December 15, 2021

To: Users of SFI Specs 10.3  
From: SFI Foundation, Inc.  
Subject: Spec 10.3B, Revision, effective December 3, 2021

## Section II.5:

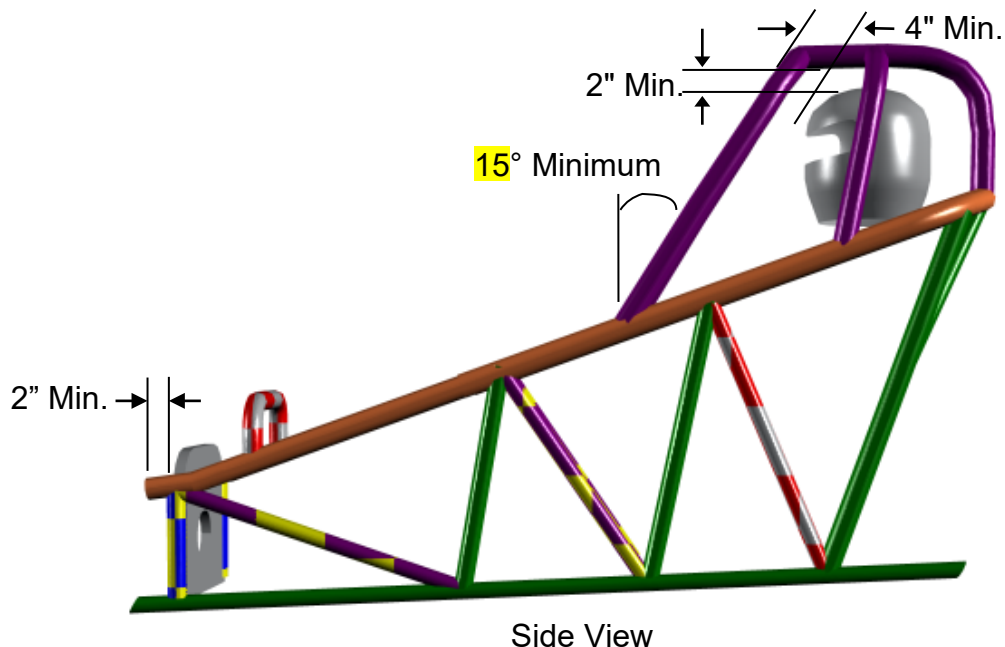
5. All butt welds must have visible reinforcement or interior sleeve(s), six (6) inches (15.2cm) minimum (3" {7.6cm} on each side of the joint center line), with visible rosette welds. Rosette welds shall be within one-half (1/2) inch (12.7 mm) from the end of the interior tube and must be a minimum of 1/4" in diameter.
